### LAND USE APPLICATION FORM

File Number(s): GEO 18-01

Project Name: Green residence Number of Lots Proposed (If Applicable): 1 JUL16 3:23PM

**REQUIREMENTS TO DEVELOP PROPERTY AT THE ABOVE REFERENCED SITE**

# C1

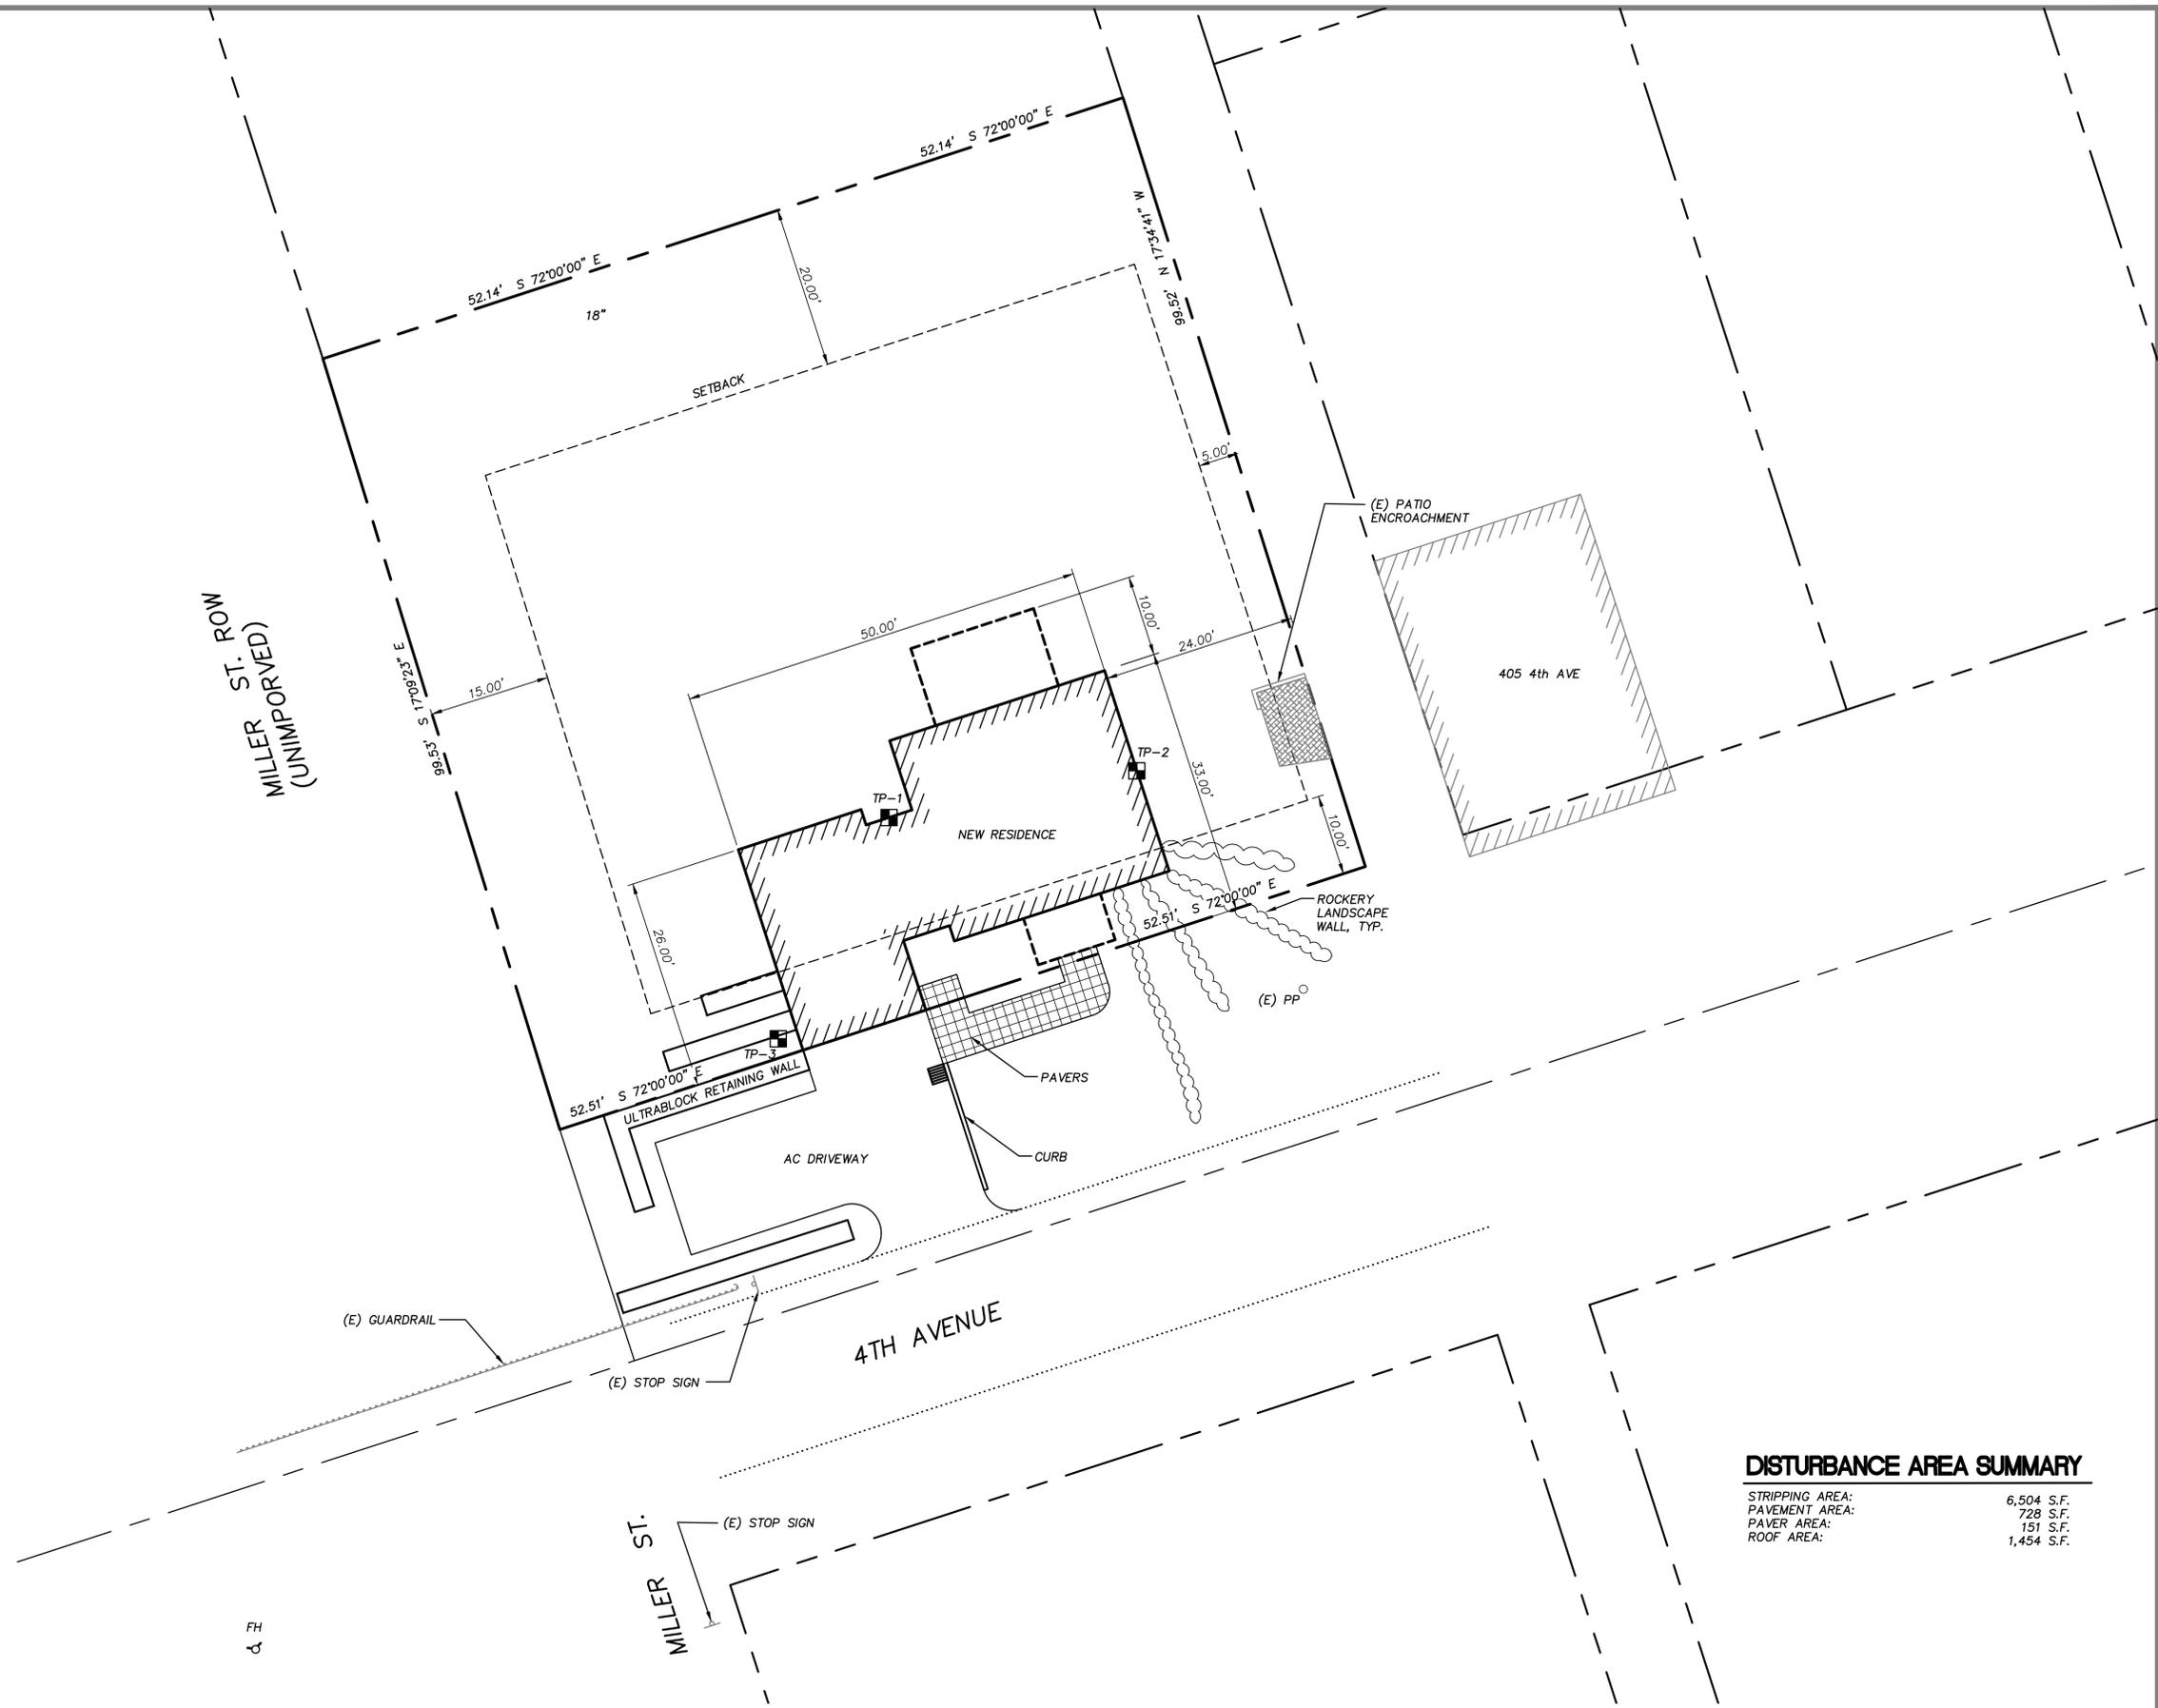
- The submitted plan shows private facilities in the 4th Avenue public right-of-way, such as private parking, retaining walls, and a private sidewalk. These private facilities need to be placed on the property and not in the public right-of-way. In the event the proposal has no ability to place all of these facilities on private property due to the geologic constraints, the City may, at its discretion, allow a permanent obstruction in the right-of-way which requires a permit, fee, staff recommendation, and city commission approval.

C2

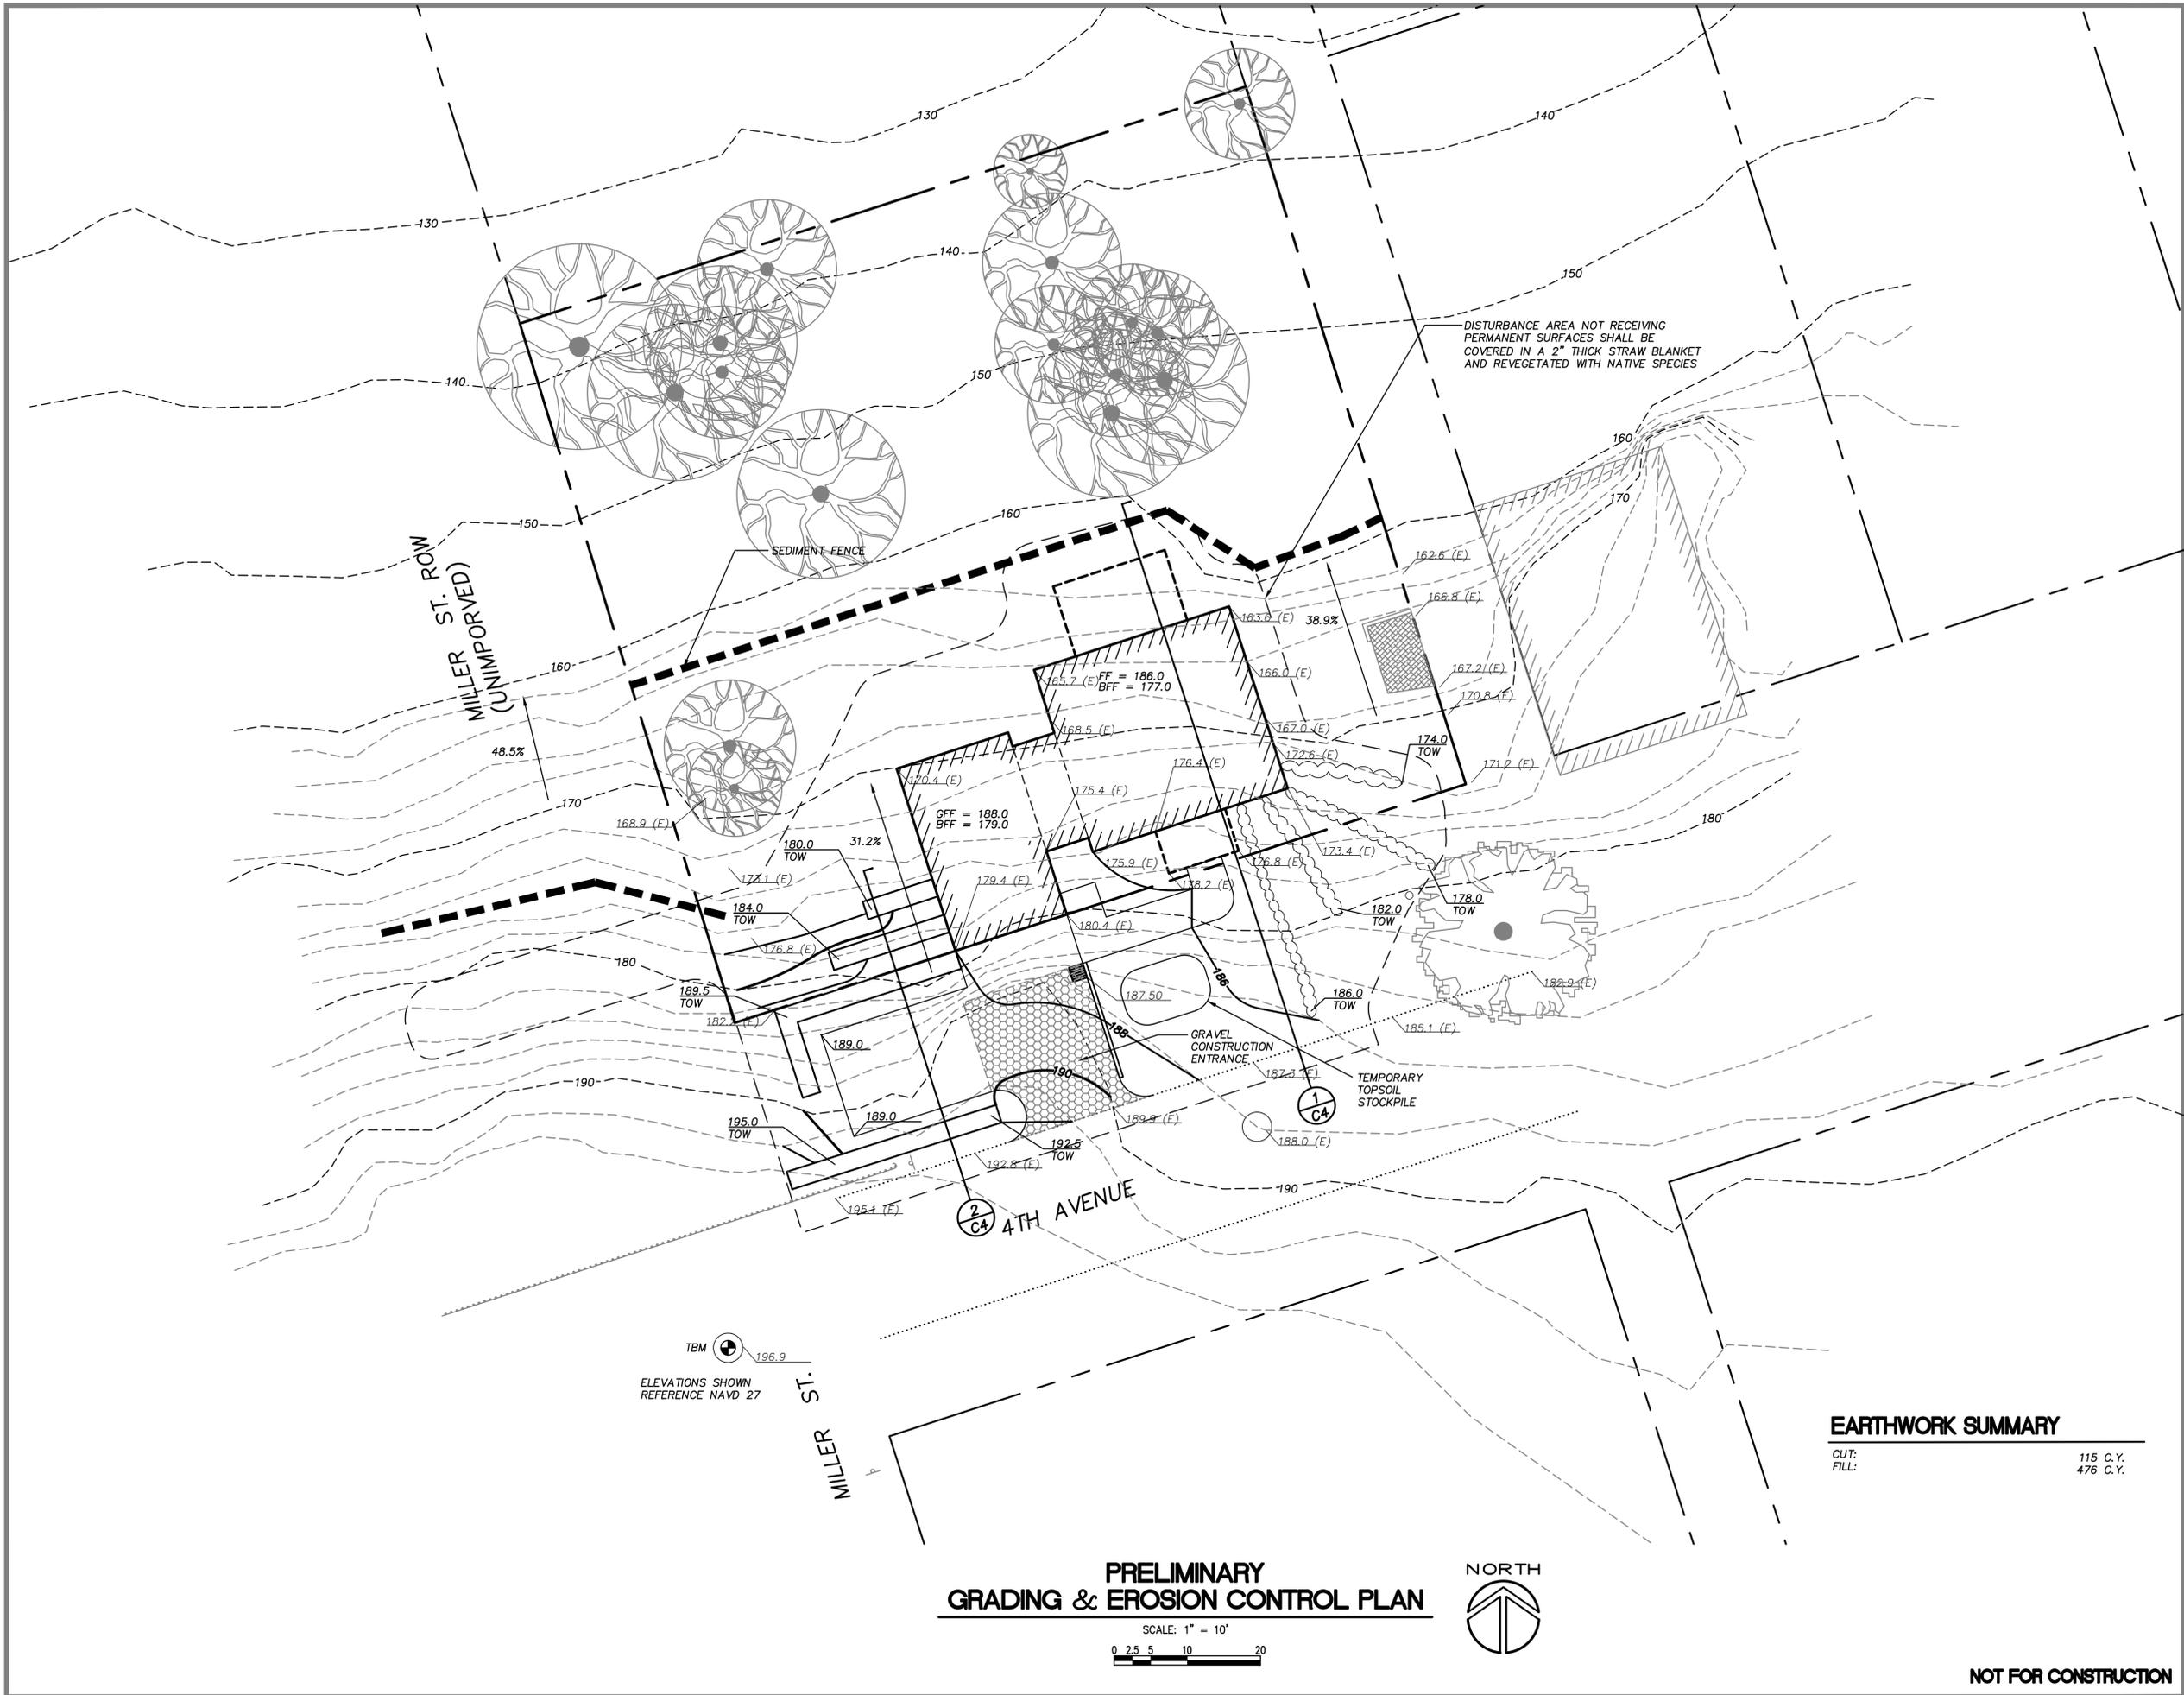
- Provide a calculation of the total volume of earthwork in cubic yards and volume to be removed or imported to the site.
- Provide approximate volume of all excavations and fills on cross-section diagrams, and documentation of the geotechnical engineer's review of the cross-section diagrams.

- Minimizing disturbance to the natural topography is a high priority. The previous proposal for Taxlots 7300 and 7303 does not meet the intent of the code. The extensive fill upslope of the house does not meet the intent of minimizing disturbance to the natural topography. Accommodate the existing natural topography with minimal driveway areas, and cuts and fills minimized to the maximum extent practicable. The homes at 502 4<sup>th</sup> Ave. provide an example of the code intent.

- Total earthwork cuts and fills were list on SEC Sheet C2 – Preliminary Grading and Erosion Control Plan dated 12/19/17. A 3D volume listed on 2D cross-sections would imply certain assumptions by the reviewer that may not be appropriate. The
